SERVICE TECHNICAL INFORMATION

ONE POINT REPAIR

REF. NO. : SI-96-013

MODEL : CSD-ES50 / ES60 / ES70 / CA-DW700M / NSX-E7M
SUBJECT : Remote control does not operate
SYMPTOM : The height of the positive terminal (+) with some AA batteries is low. When such batteries are used, the battery does not make contact with the positive terminals (+) of the remote control unit and so the unit does not operate.

Remote Control (bottom)

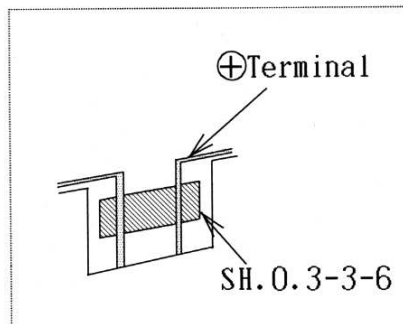
(Battery with which this condition has been currently discovered: Duracell)

REMEDY : Attach a spacer to the positive terminals (arrow) of the remote control unit (refer to the figure below).

Use tweezer to attach to the back of the positive terminal.
